Central Planning Authority

Agenda for a meeting of the Central Planning Authority to be held on **September 29, 2021 at 10:00Am, in Conference Room 1038, 1st Floor, Government Administration Building, Elgin Avenue.**

CPA/20/21

Figure 1: DOE's 2013 Habitat Map Extract showing Application Parcel Outlined in Blue
 Retaining vegetation can provide benefits to the property owner and the surrounding area, including:

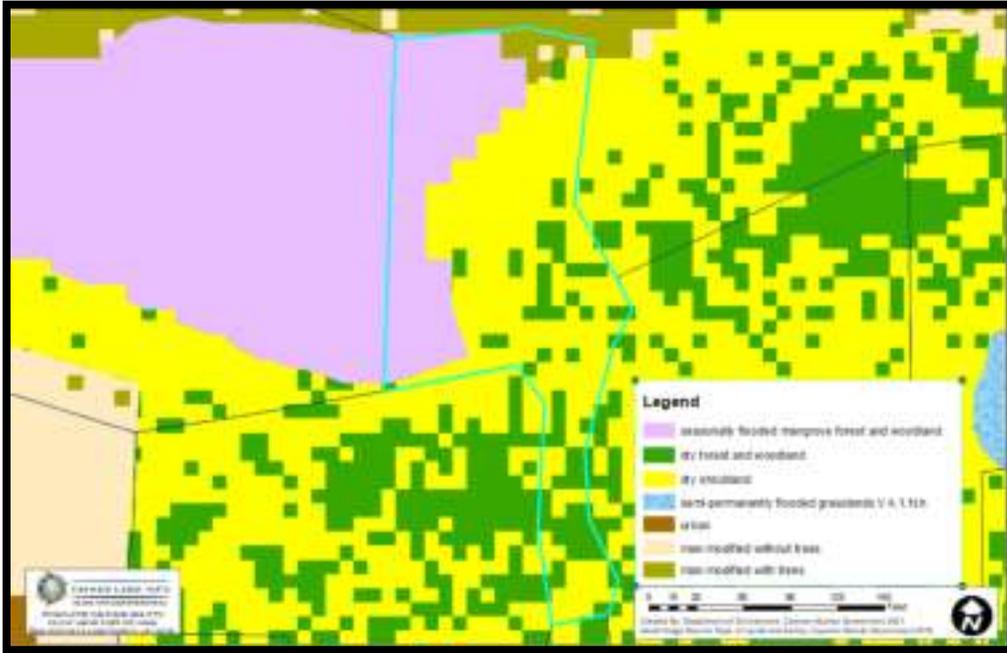
The Applicant proposes to clear primary habitat, namely dry shrubland, dry forest and seasonally flooded mangrove forest and woodland. There is no justification provided from the applicant, and there is no development proposed to justify the loss of primary habitat. Clearing this site in the absence of an approved development or use, is considered to be speculative clearing which is not a practice that the DoE supports. Speculative land clearing removes the option of retaining native vegetation outside the footprint of a prospective development. It also results in the fragmentation of undisturbed primary habitat in the surrounding area. It is important to note that fragmentation is continuing to affect primary habitat interrupting important ecological services, wildlife corridors and facilitating the introduction of invasive species on cleared land.

Figure 1: Google Map screenshot showing application site location outline in blue in 2021

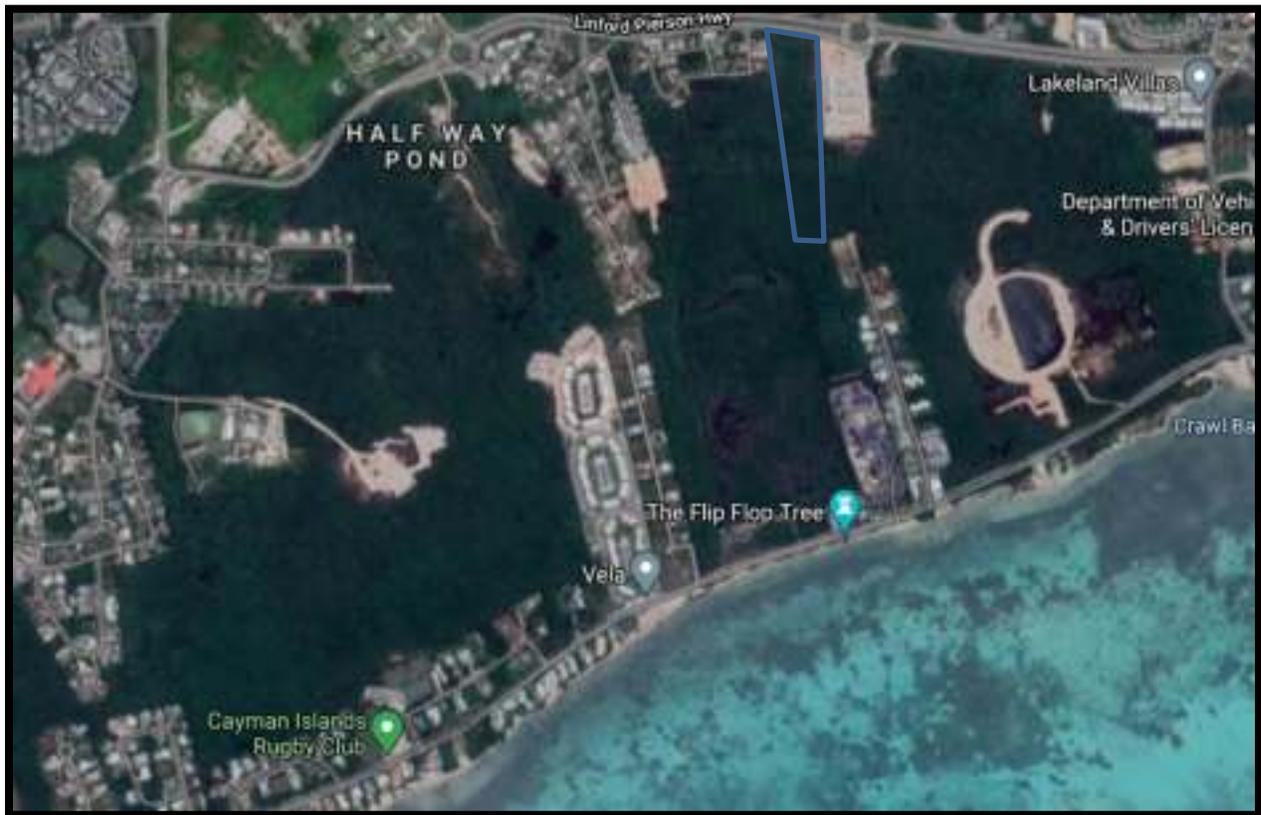
The application site consists of primary habitat, classified as seasonally flooded mangrove forest and woodland, as shown on Figure 1. Mangroves are listed as Schedule 1, Part 2 protected species under the National Conservation Law (NCL) (2013) and there is a Mangrove Conservation Plan which came into effect in April 2020.
